**GEOTECHNICAL ASSESSMENT OF**  
**GOLDEN PIKE CUTBACK**  
**for**  
**KCGM PTY LTD**

At the request of Mr Gary Lye of KCGM Pty Ltd (KCGM), BFP Consultants Pty Ltd (BFP) has reviewed the proposed pit wall design for the Golden Pike Cutback at KCGM's Super Pit in Kalgoorlie. This report also assesses the implications of the Golden Pike Cutback in relation to Department of Industry and Resources (DoIR) pit abandonment guidelines (Reference 1 and Appendix A).

## **14.0 REVIEW OF GOLDEN PIKE CUTBACK DESIGN**

**HAINES AND TERBRUGGE  
SLOPE ANGLE FROM RMR**

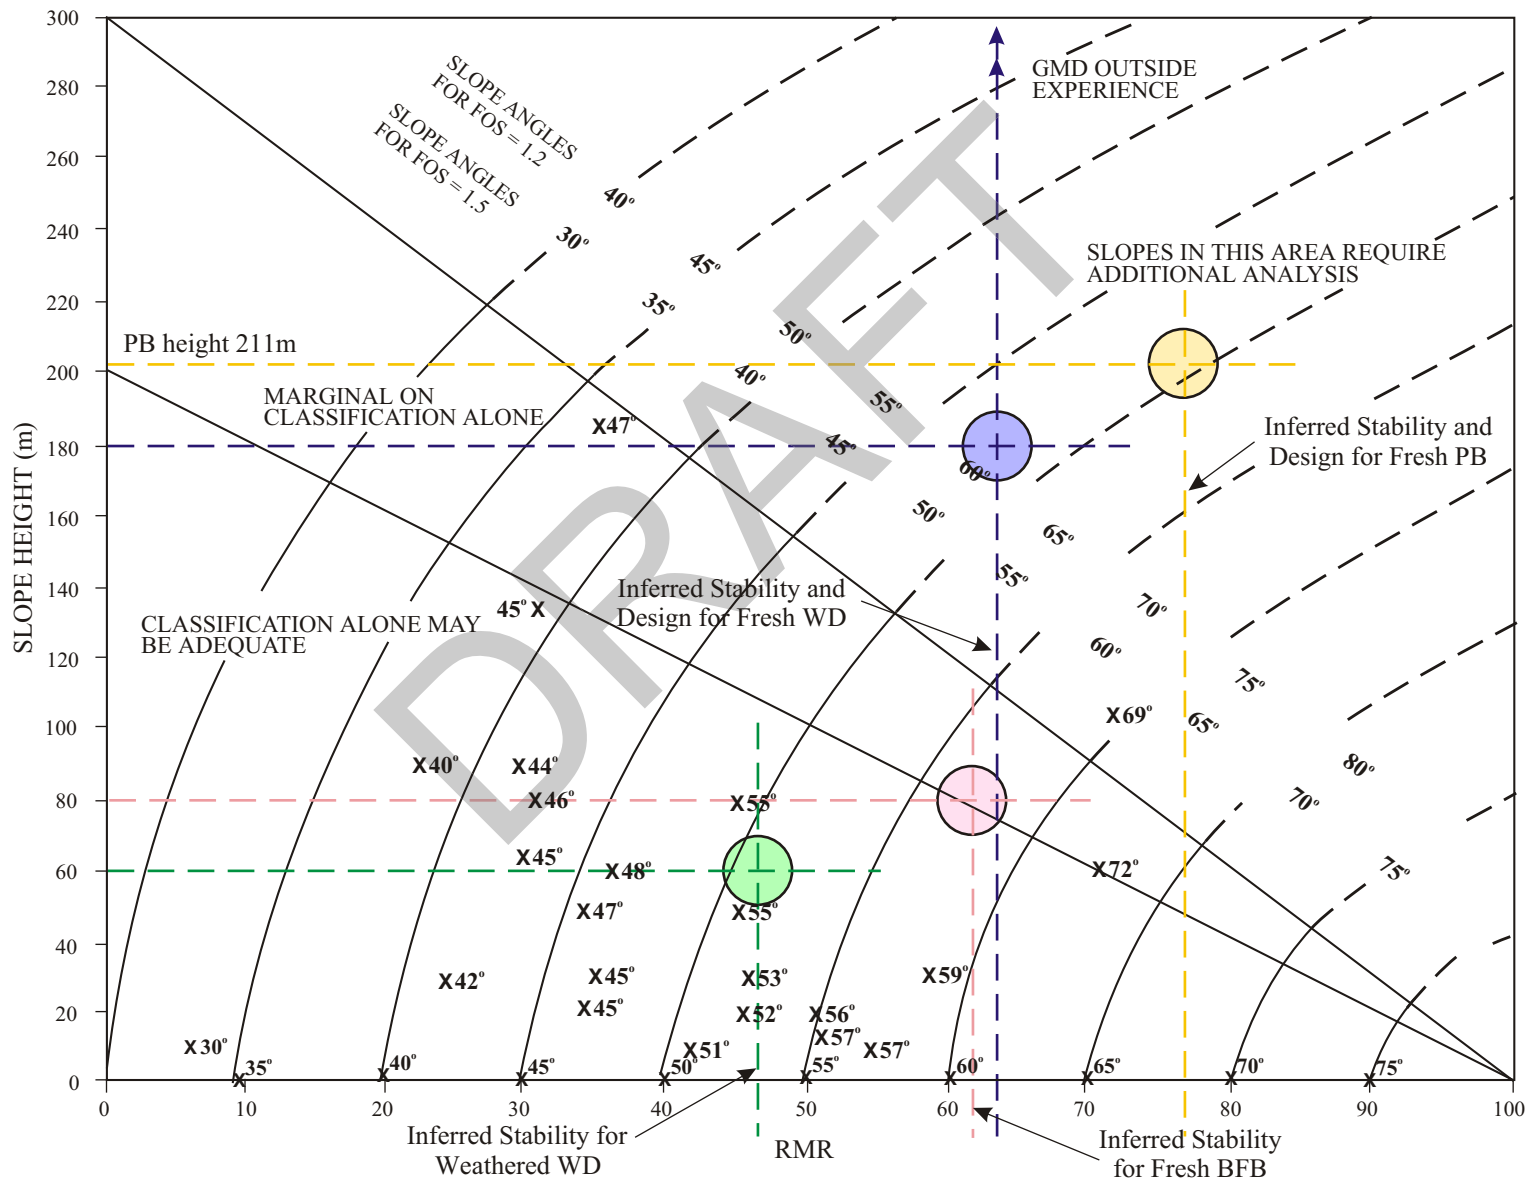
The results of the rock mass classification have been plotted on a stability chart, shown in Figure 11. The GMD has a design slope exposure of greater than 300 m, therefore the data was not plotted on the stability chart in Figure 11. The positions indicate that the possibility of an overall failure in both the weathered and fresh rocks is low.
